3.8 STORMWATER MANAGEMENT COMMENTS AND RESPONSES

Figure 3.8-1: Watercourse and Wetlands

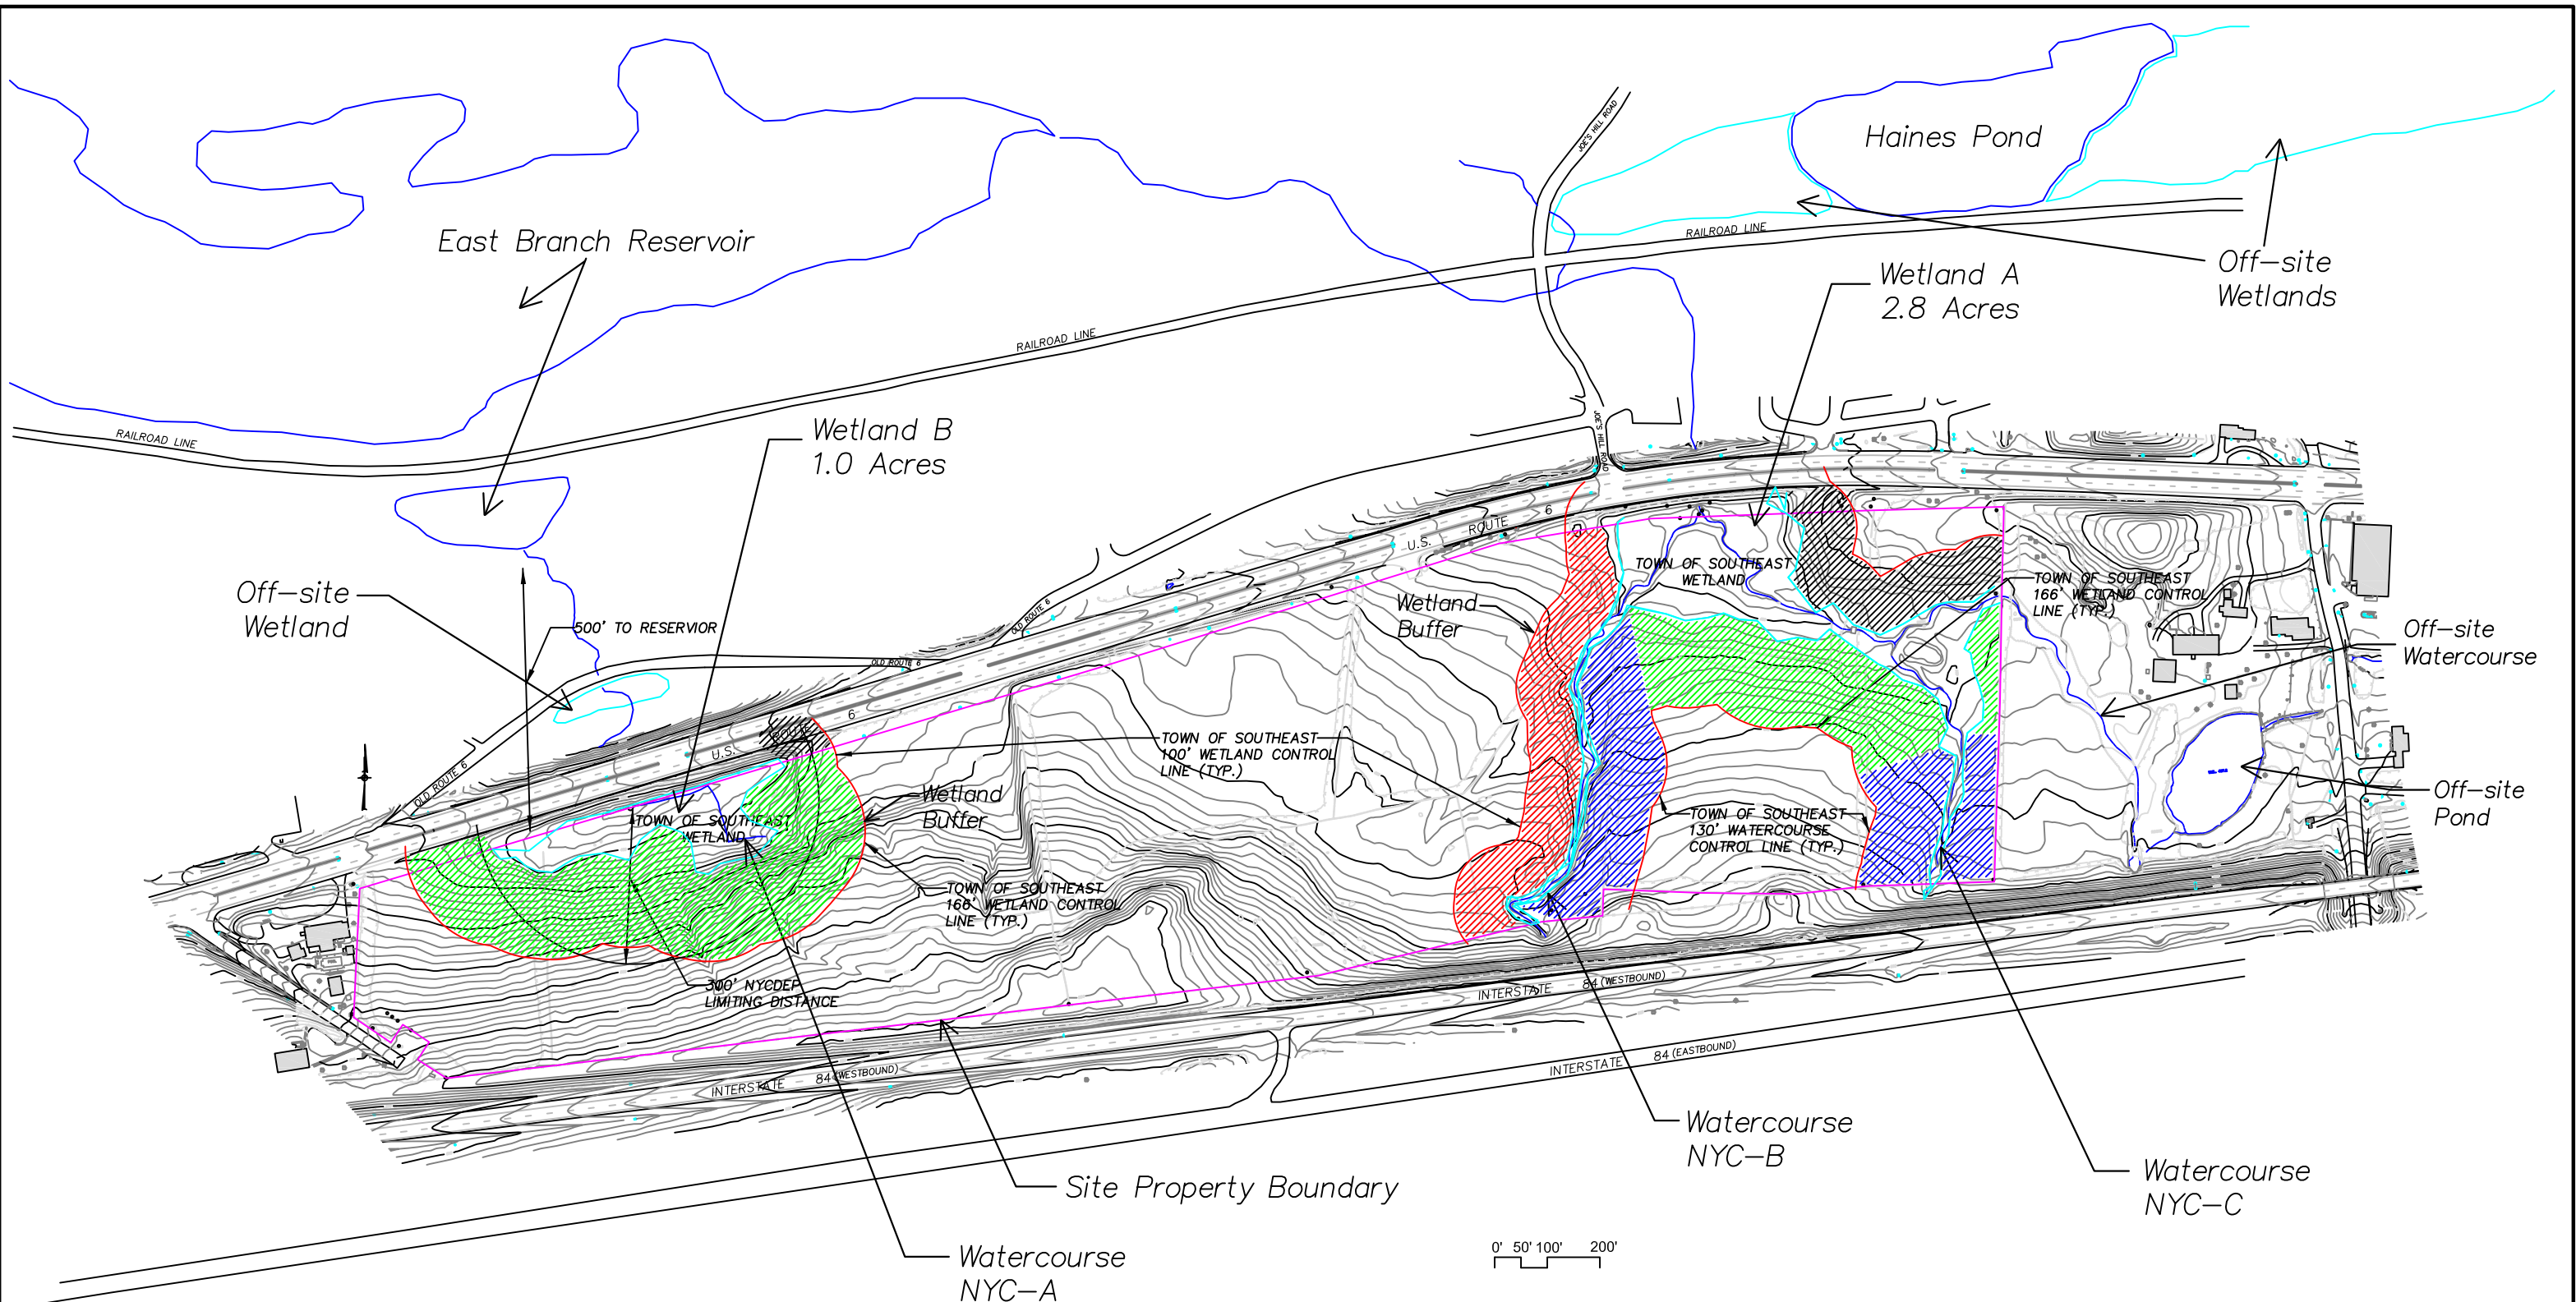
Comment 3.8-16 (AKRF, Letter #4, September 29, 2008): Have the watercourses and reservoir stems been certified or verified by NYCDEP?

Response 3.8-16: *As documented in the DEIS, "There are three watercourses on the property designated as NYC-A, NYC-B and NYC-C. All three watercourses have been identified, delineated and their locations validated by the NYCDEP (November, 8 2006)."*

Refer to Figures 3.8-1 (Watercourses and Wetlands) and 3.8-2 (NYCDEP Signed Watercourse Map), versions of which were included in the DEIS, for depictions of each of the watercourses and the NYCDEP signed version of the watercourse delineation map respectively. Please note that the watercourses are part of the baseline drawings for this project. As such, they are shown on all the appropriate figures and drawings in both the DEIS and FEIS.

The confirmed survey map, dated November 8, 2006, is binding upon the NYCDEP for five years following the date of the confirmation or November 2011.
